Preservation Department – Item 1, LPC-20-10551

1 East 70th Street – The Frick Collection

Ammendment to
LPC CoA #19-25099 to Modify
Approved Mechanical Screen

06 October 2020

1 PROPOSED NORTH-SOUTH SECTION
1" = 30'-0"

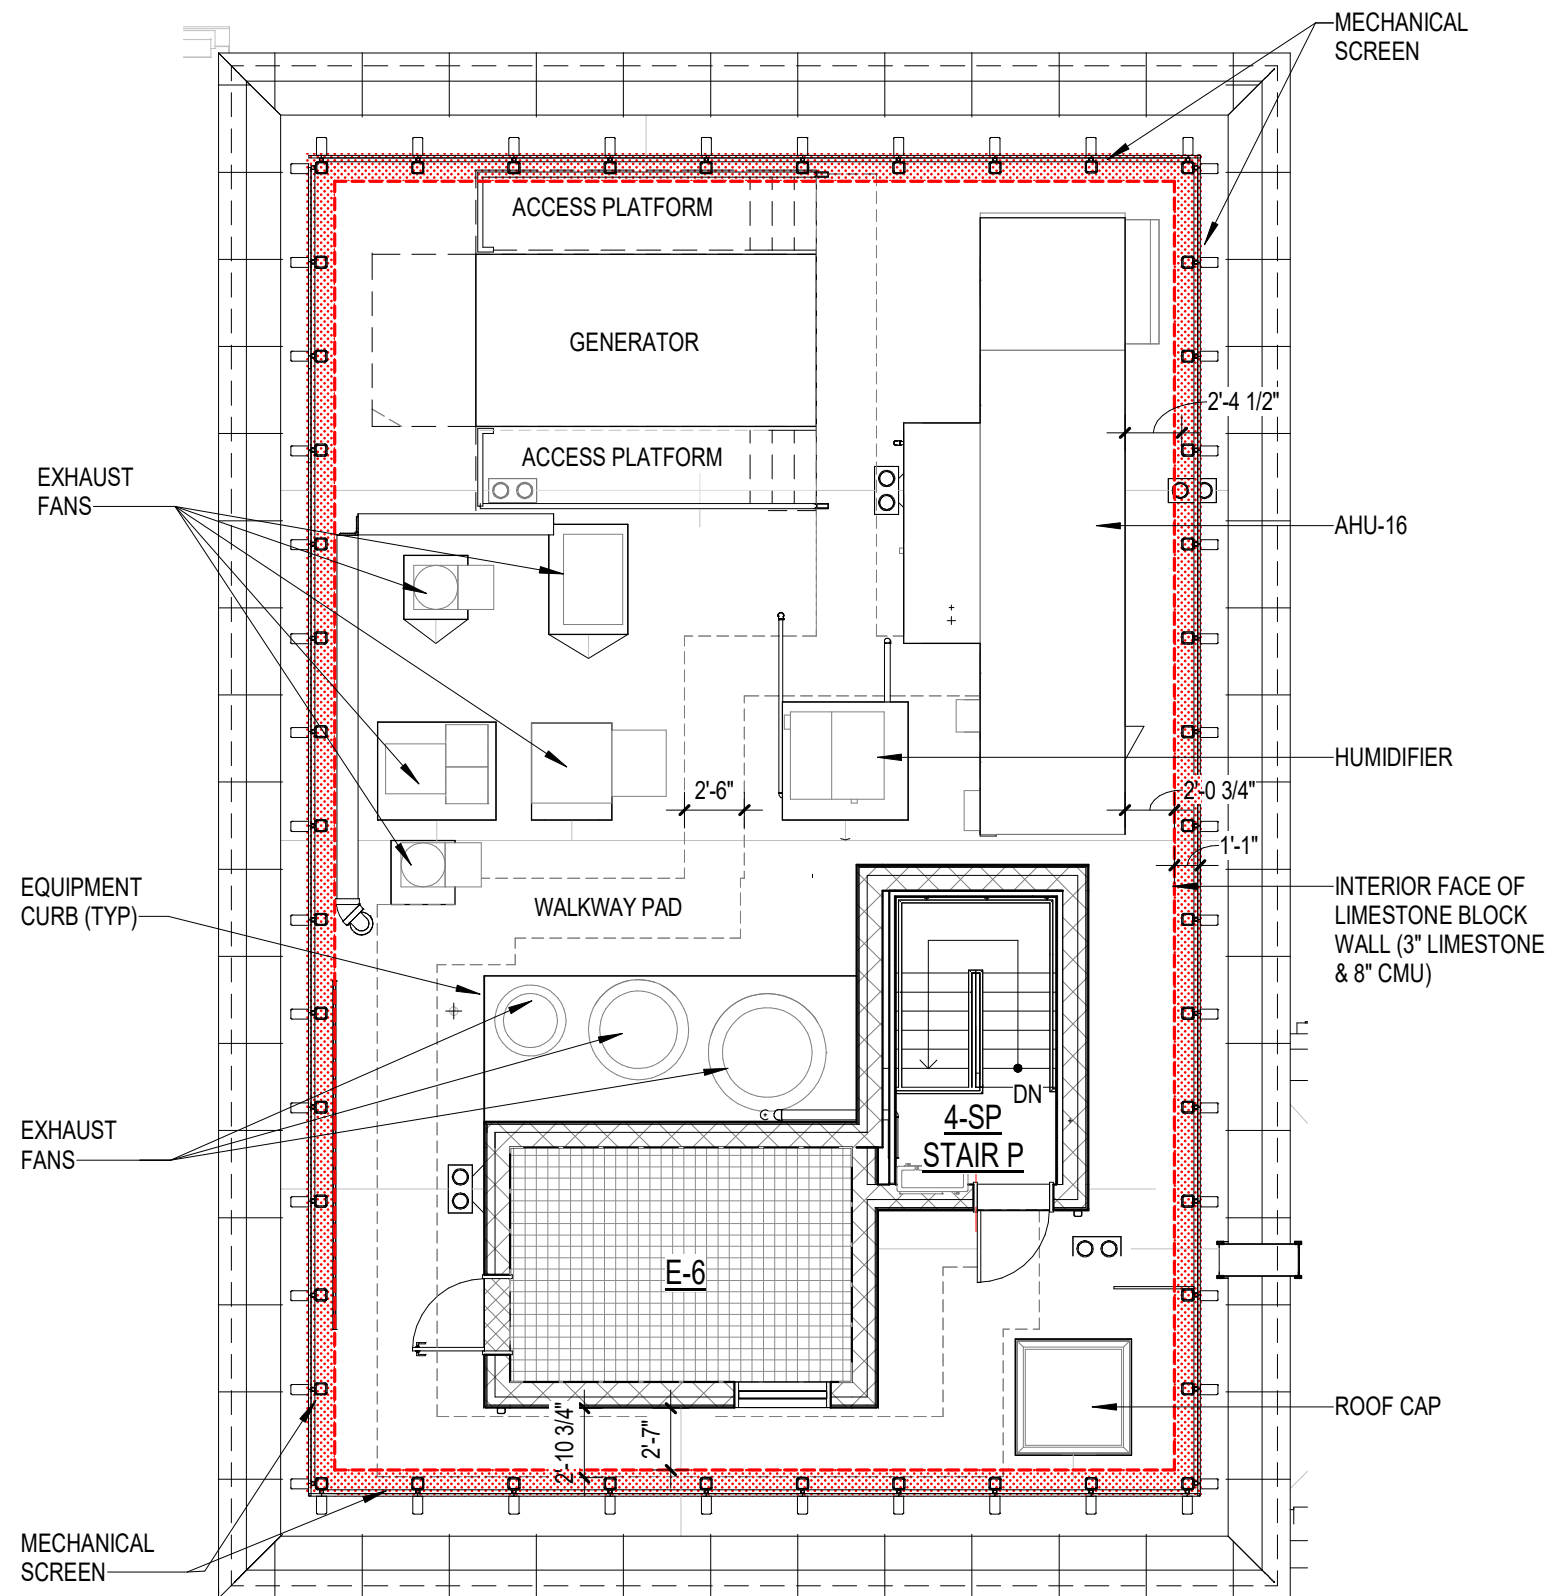
LIMESTONE CLAD BLOCK
(FULL THICKNESS SHOWN IN )
SPACE REMAINING BETWEEN BACK
OF LIMESTONE & MEP EQUIPMENT
DOES NOT ALLOW FOR REQUIRED
CLEARANCES

LIMESTONE ON HONEYCOMB
RESOLVES ACCESS ISSUES.
TOO FRAGILE FOR USE AT
MECHANICAL ROOF LEVEL DUE TO
ROOFTOP MAINTENANCE & FACADE
CLEANING

COPPER SCREEN
PROVIDES REQUISITE SPACE AND
RESOLVES ISSUES OF DURABILITY
AT ROOFTOP

2 MECHANICAL SCREEN SECTION
3/4" = 1'-0"

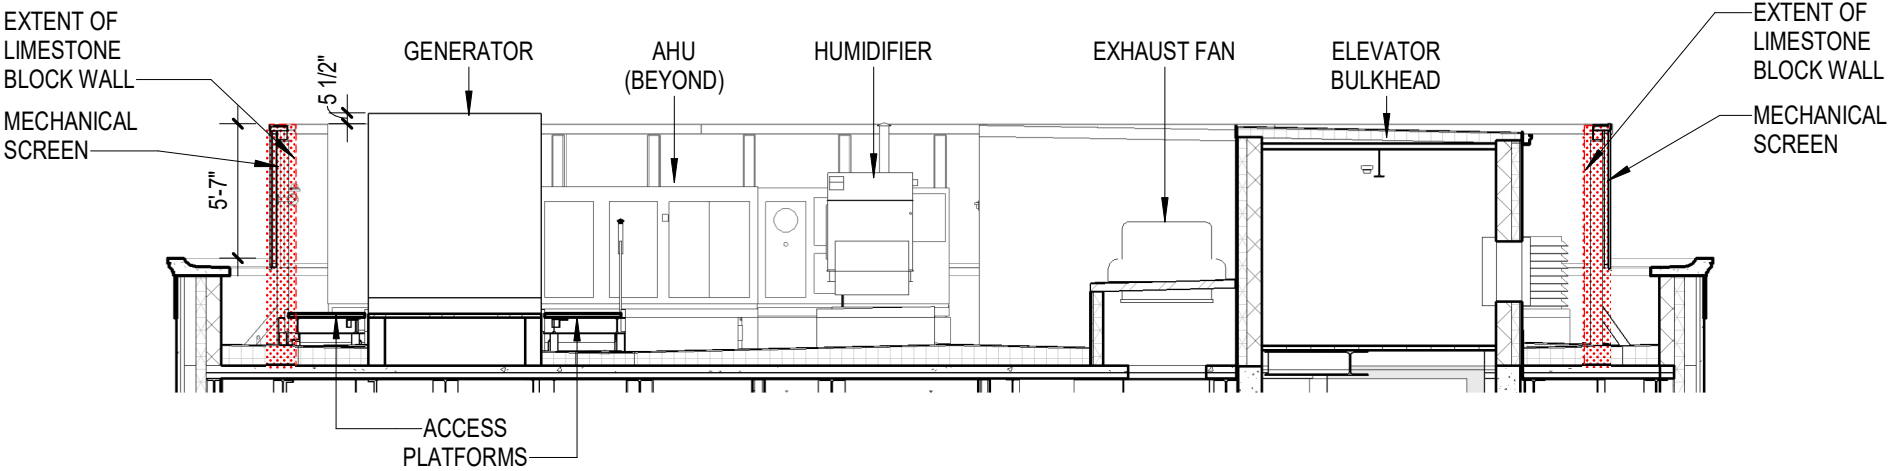
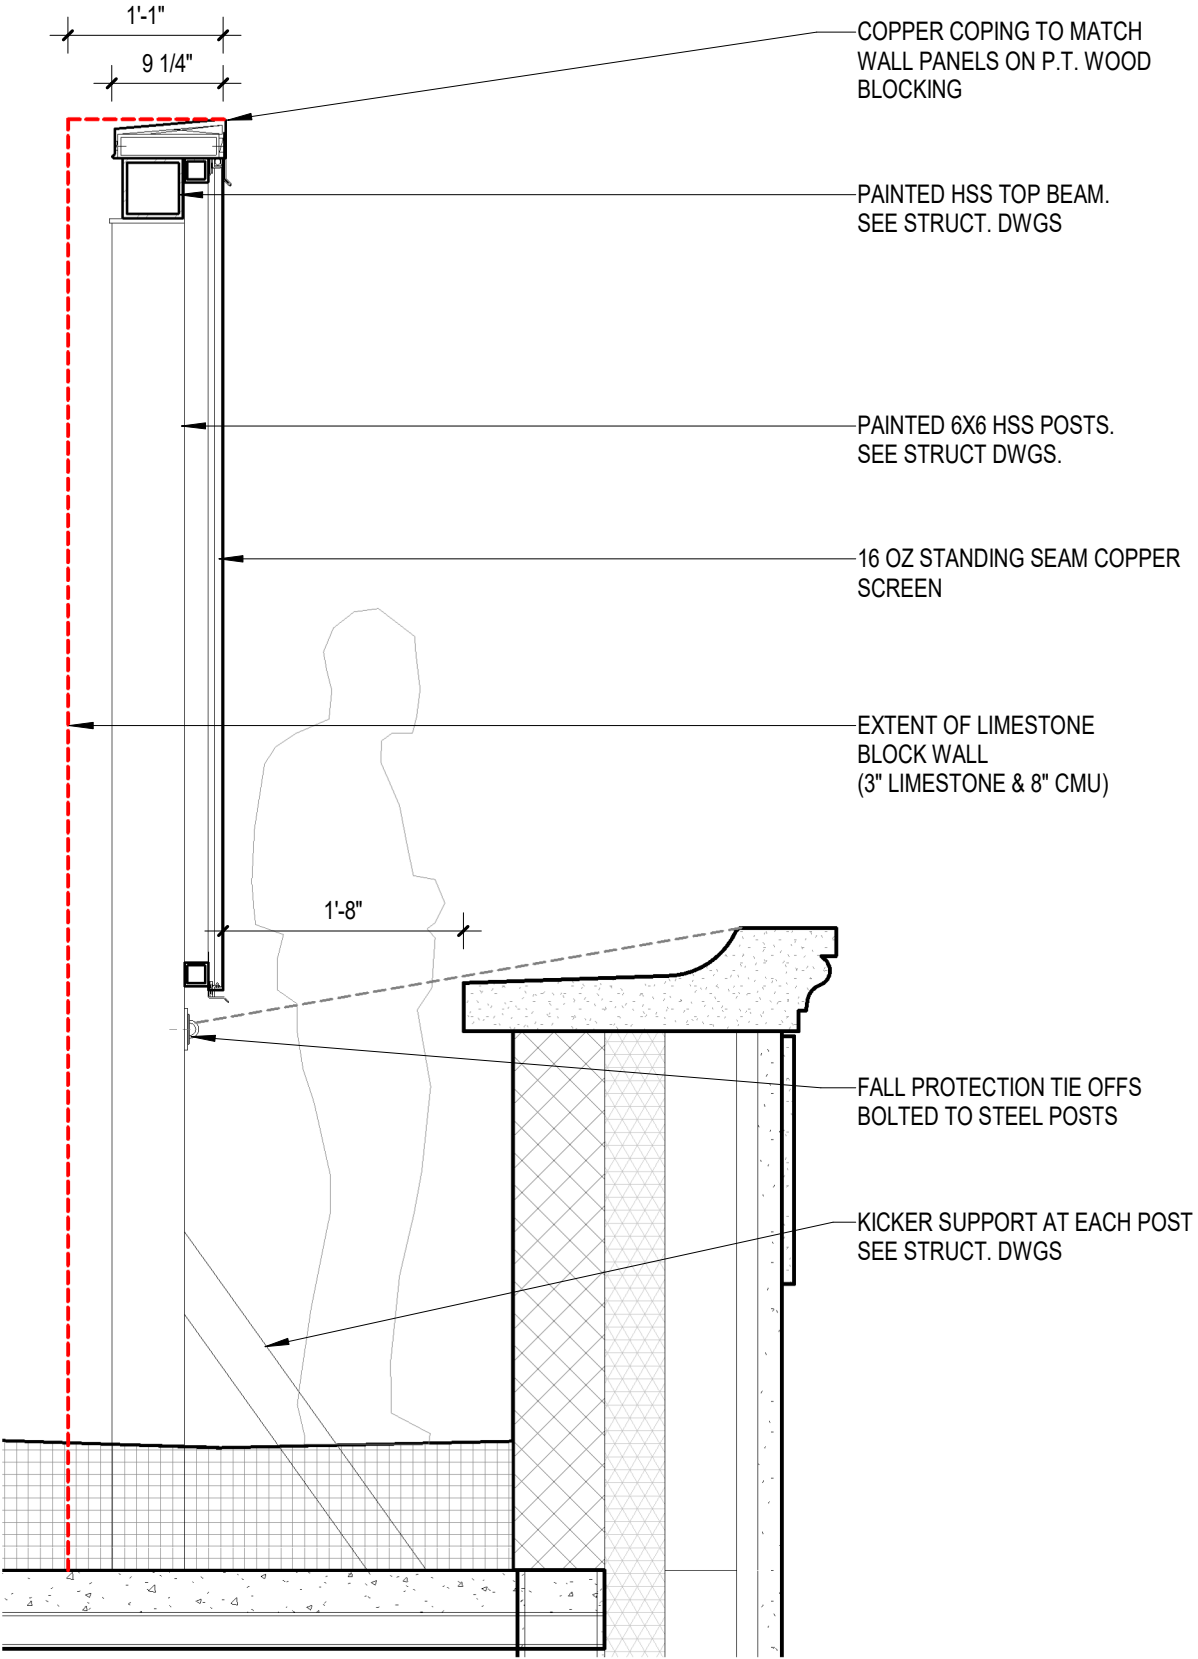
LIMESTONE CLAD BLOCK
(FULL THICKNESS SHOWN IN)
SPACE REMAINING BETWEEN BACK
OF LIMESTONE & MEP EQUIPMENT
DOES NOT ALLOW FOR REQUIRED
CLEARANCES

LIMESTONE ON HONEYCOMB
RESOLVES ACCESS ISSUES.
TOO FRAGILE FOR USE AT
MECHANICAL ROOF LEVEL DUE TO
ROOFTOP MAINTENANCE & FACADE
CLEANING

COPPER SCREEN
PROVIDES REQUISITE SPACE AND
RESOLVES ISSUES OF DURABILITY
AT ROOFTOP
